MARCH 2011 INSPECTION REPORT
To protect, conserve and enhance the quality of Wyoming's
environment for the benefit of current and future generations.

North of Glenrock, off Ross B.

Subject: March 2011 Inspection Report, Cameco Resources, Permits 603 & 633

Figure 2 Area of Modu-tank spill, topsoil stripped, Frac tanks replaced the Modu-tank

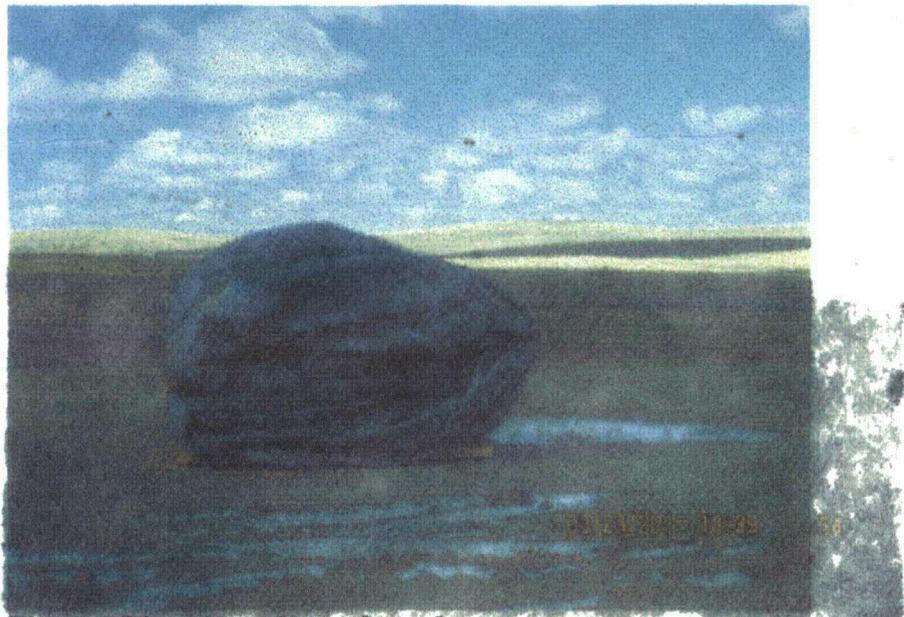
6. The surface spill at MU-K-North which resulted from the accident of the modu-tank during the wellfield pump test is considered a reportable spill and should be reported (WDEQ/WQD Chapter 4, Section 3 and 4). Please provide the spill report to the appropriate agencies including LQD.
